City of
Richmond

Report to Development Permit Panel

File: DP 17-793478

Re: **Application by TL Housing Solutions Ltd. for a Development Permit at
4360 Garry Street**

**UNITS PLANS
 H/C UNITS**

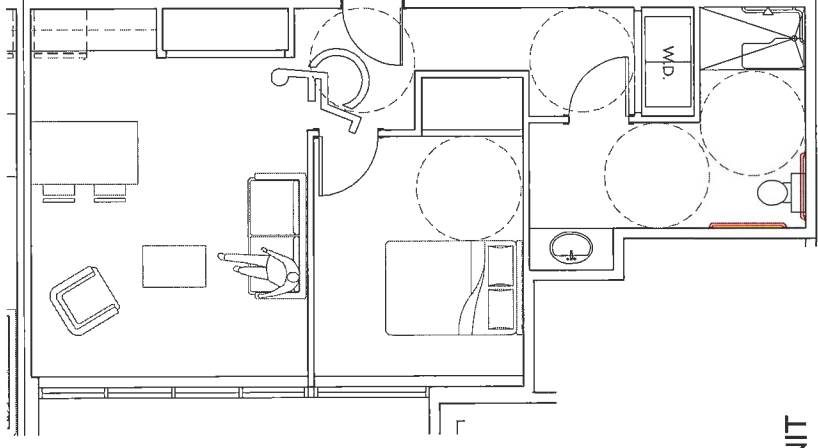
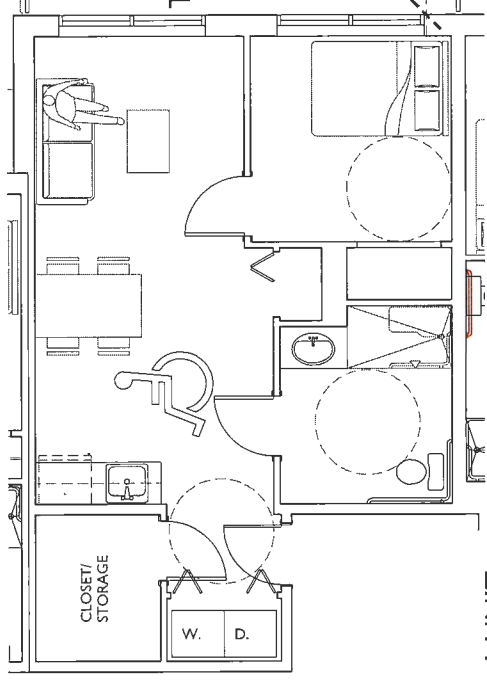
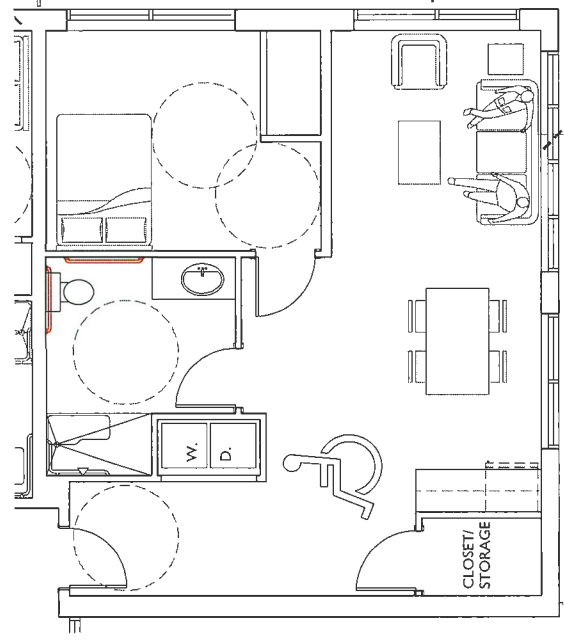
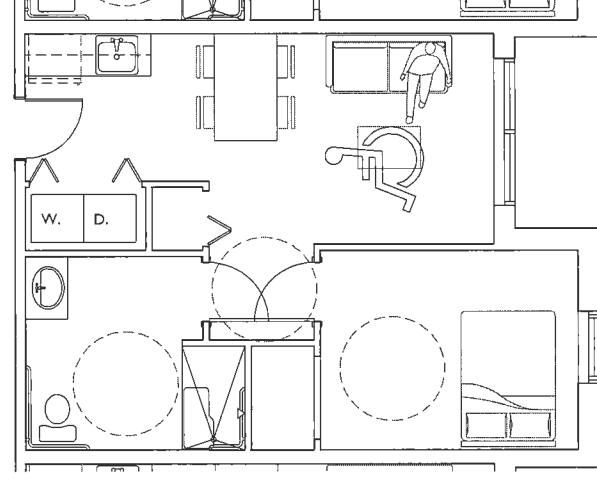
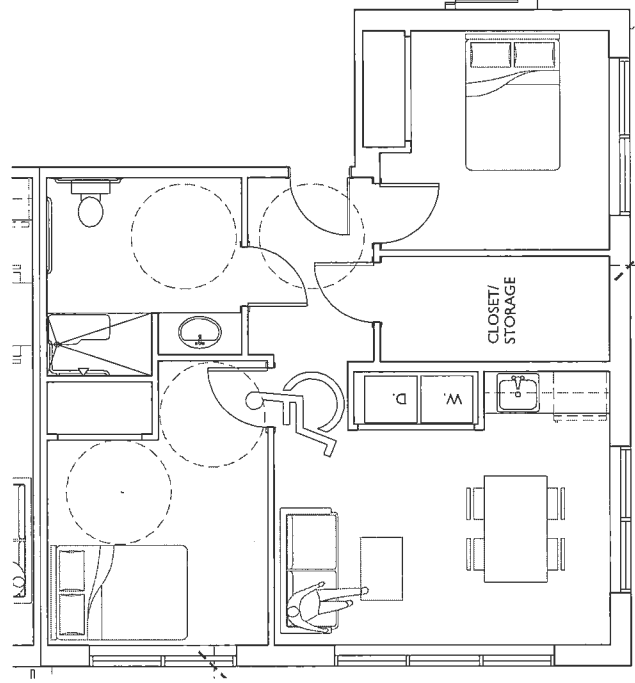
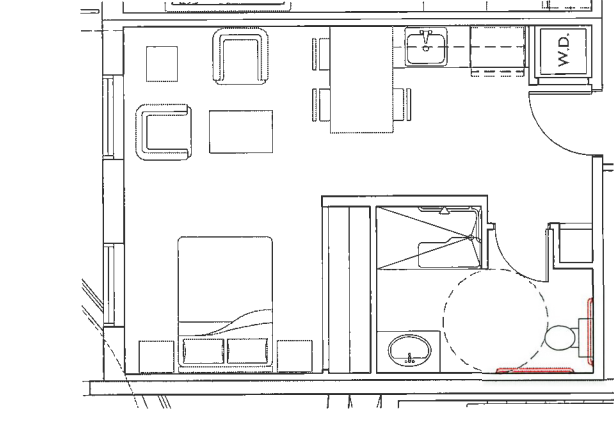
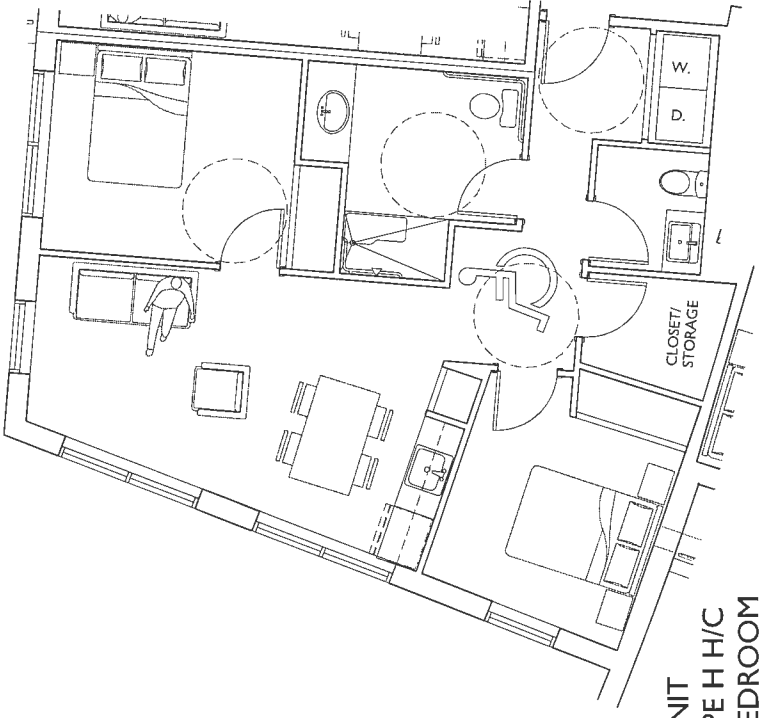
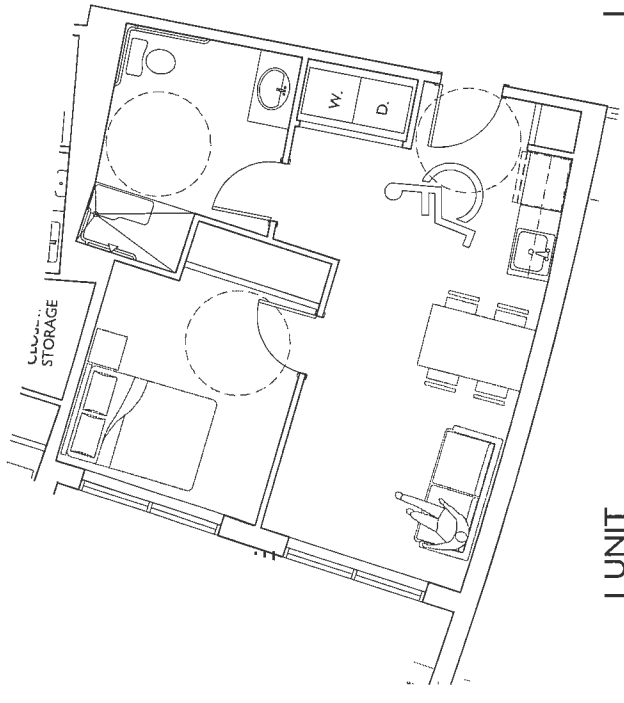
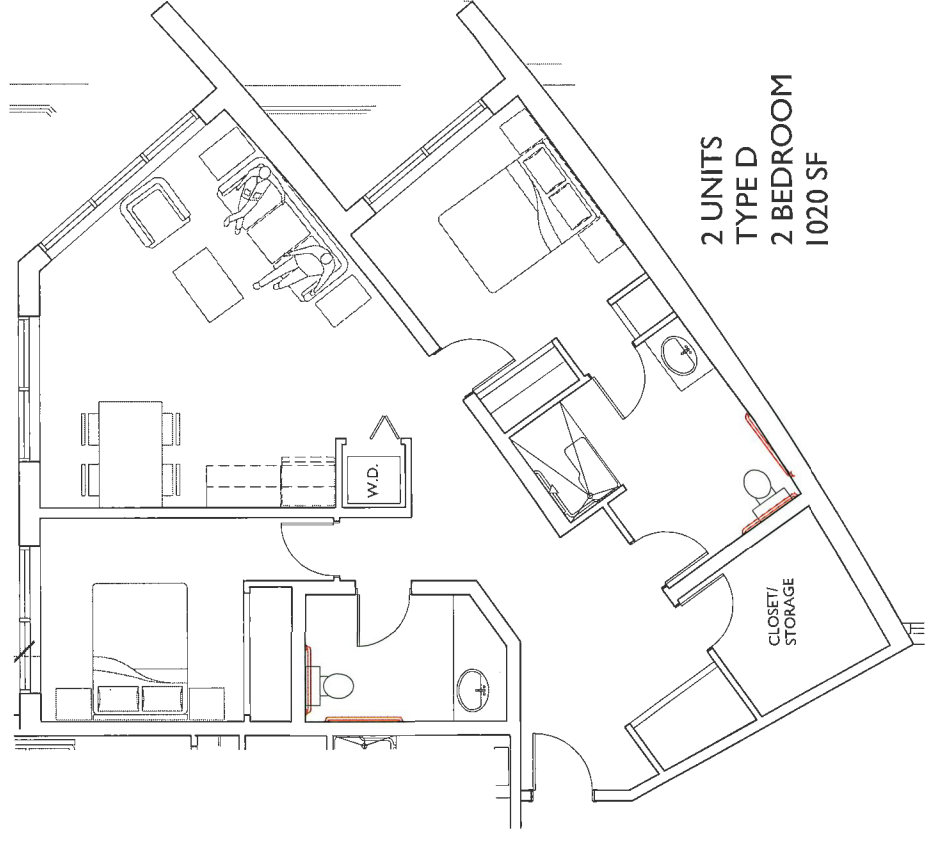
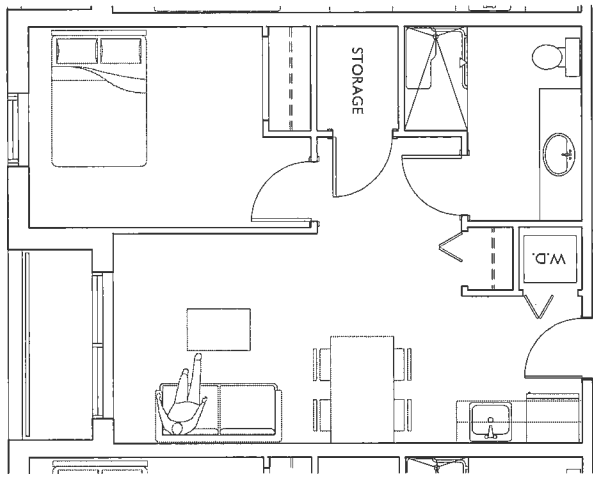
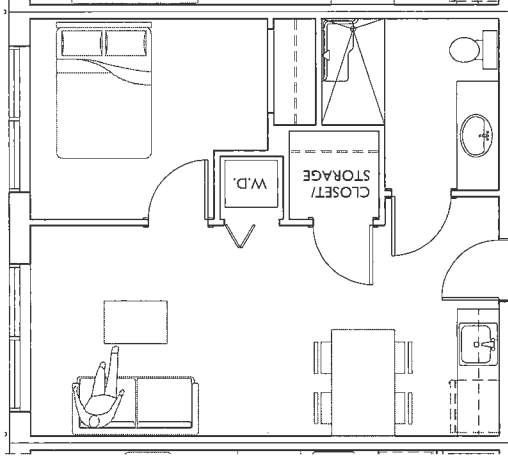
- more detailed individual units plans and information are needed to provide comments from a universal accessibility perspective; detailed design of washrooms are not included in the large drawings provided by the applicant; suggest that the applicant install outward swinging doors as opposed to inward swinging doors in ensuite washrooms for safety and accessibility of residents;

- appreciate the accessibility of the second floor;
- support the number of proposed fully accessible units; the applicant could have provided floor plans for the adaptable units;

Typical unit plans are now provided at a larger scale. Outward swinging bathroom doors have been provided.

Large scale floor suite plans have now been provided.

1 - SOUTH ELEVATION: FENCE/TRELLIS AND WHEELCHAIR RAMP/WALL
 SCALE: 1/8" = 1'-0"

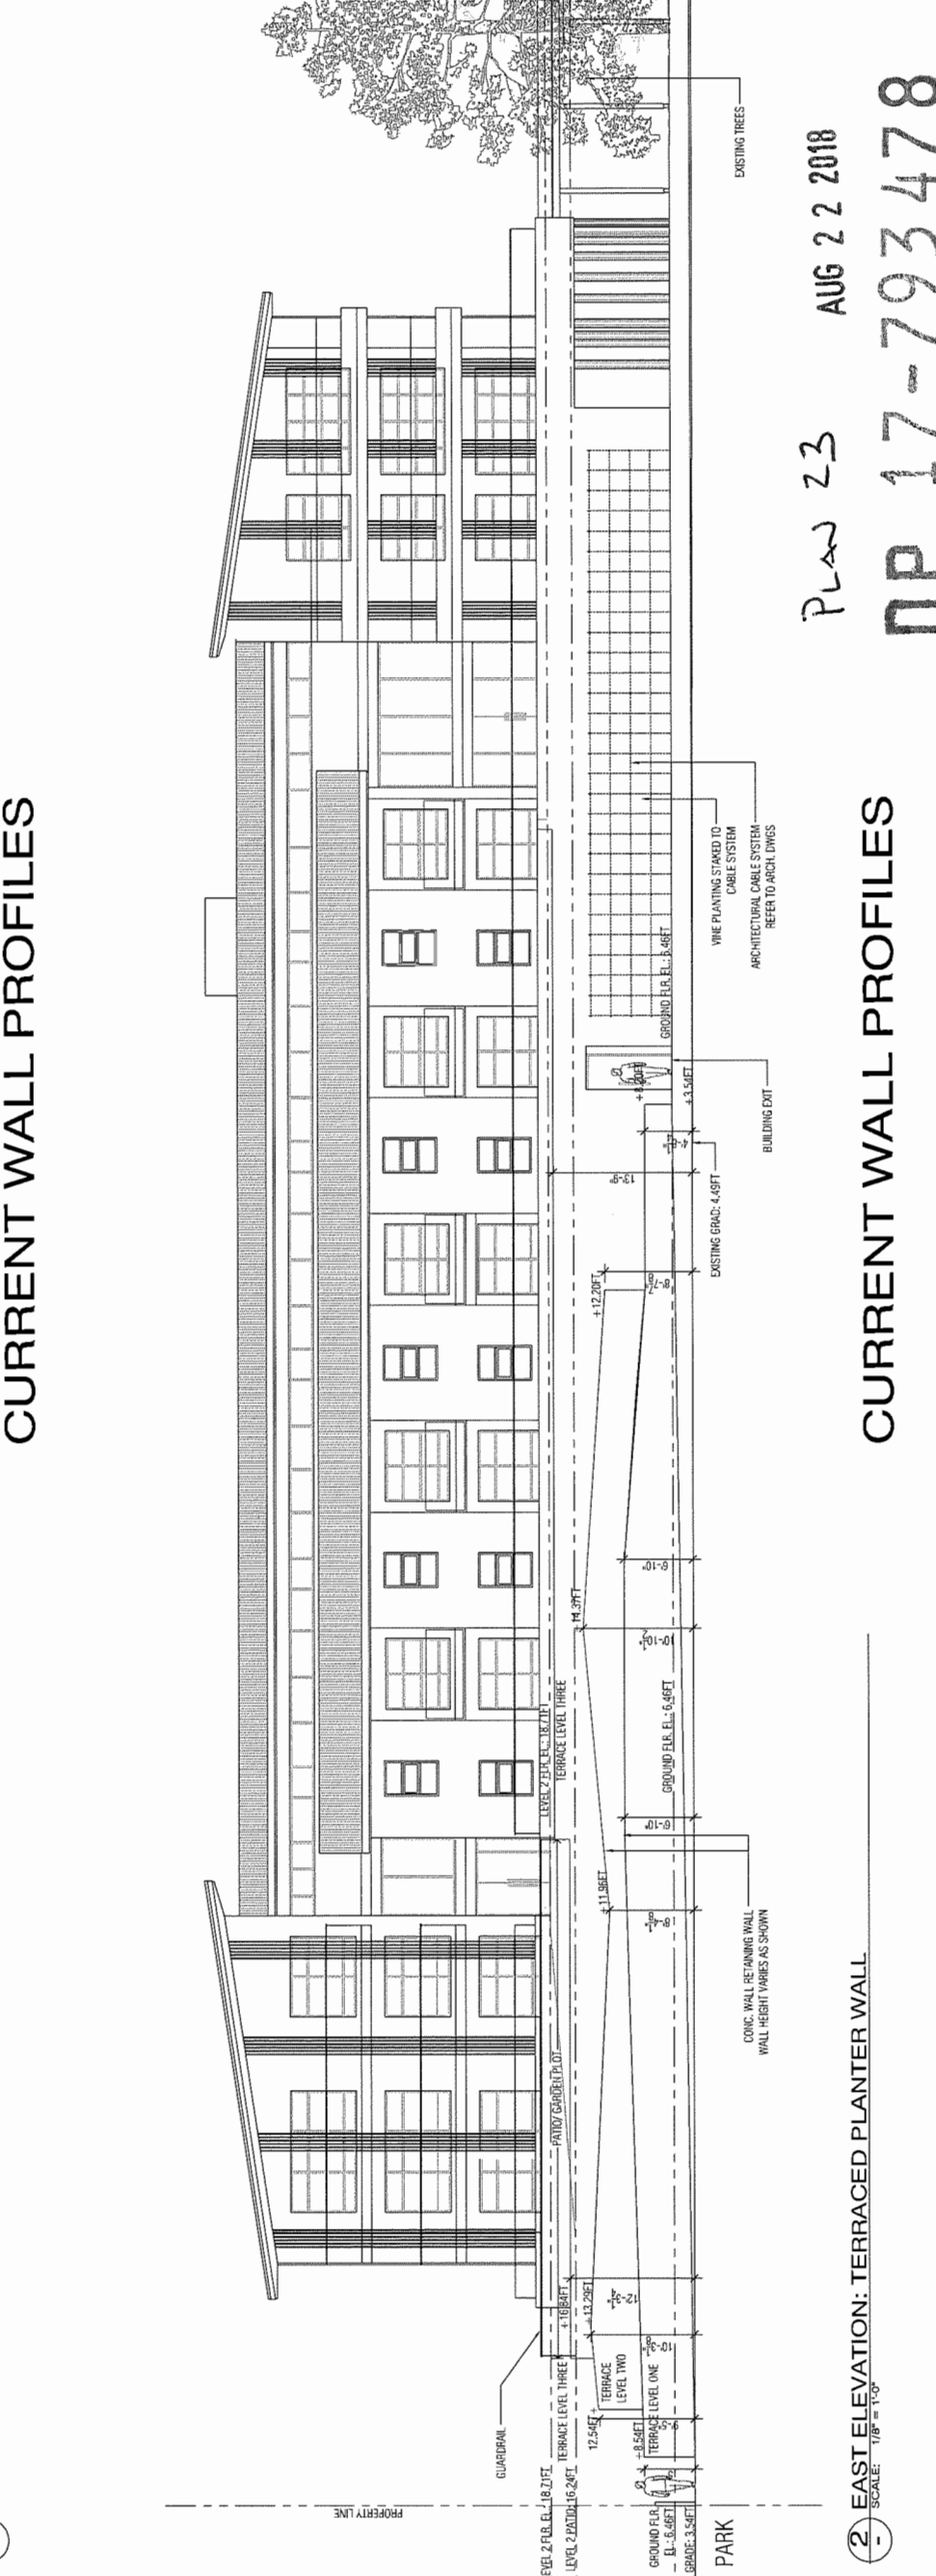
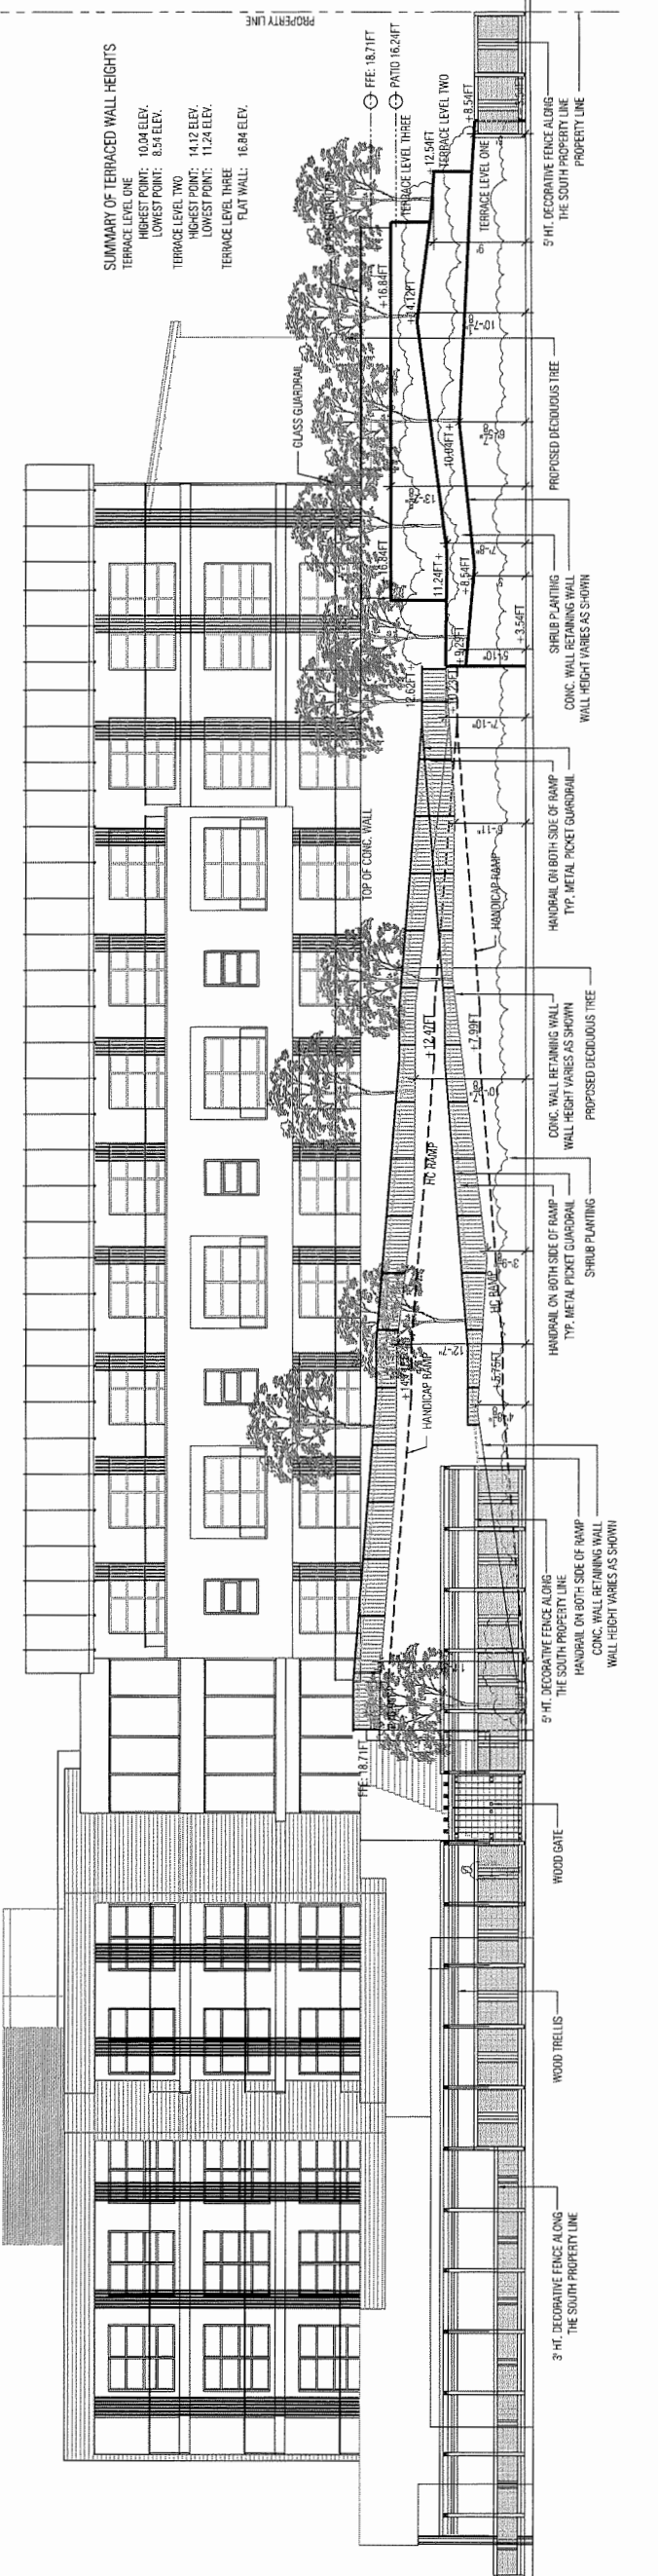
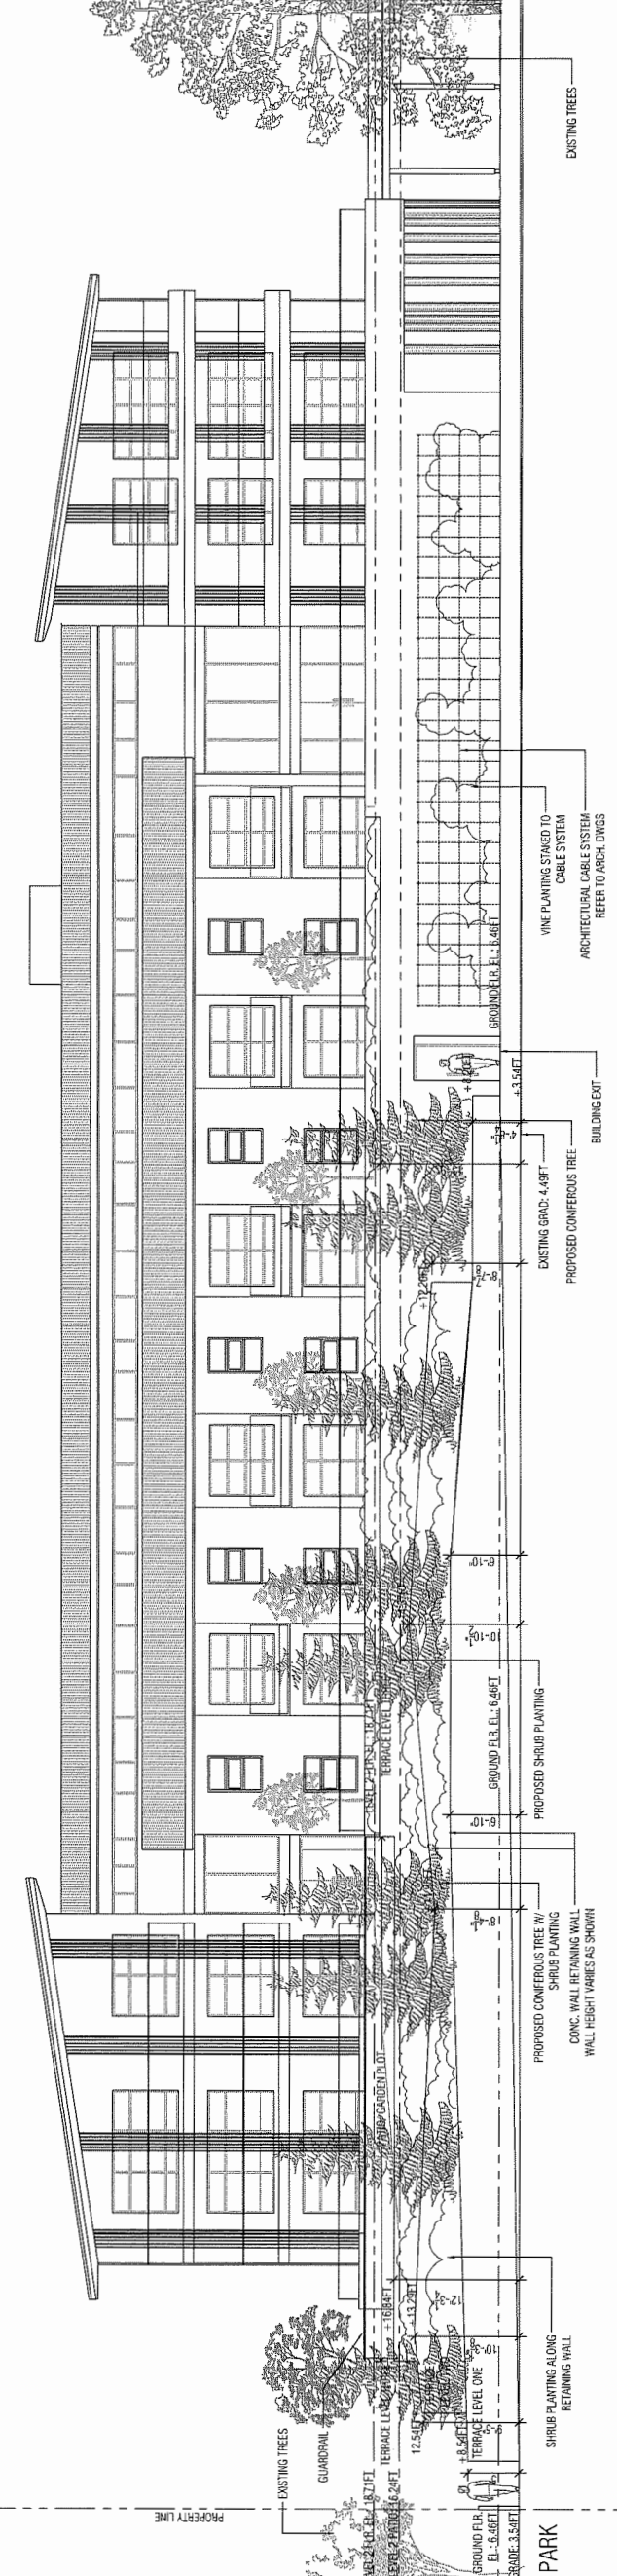
- the south concrete wall of the building appears massive from the Steveston Community Park point of view; consider installing the planting material on the east wall to the more visible south wall;

- support the comment that the reference/theme of a mountainous landscape being represented in the design of the concrete retaining walls along portions of the south and east part of the site is out of context with existing development in the surrounding area;

- consider installing larger landscape planters in lieu of small, thin landscape planters which are more difficult to maintain;

Planting to be accommodated.

Planters are 4.5 ft wide inside to inside dimension which is adequate for shrub and small tree planting. Due to requirement to have undulating wall profile and terraced approach we cannot widen planters.
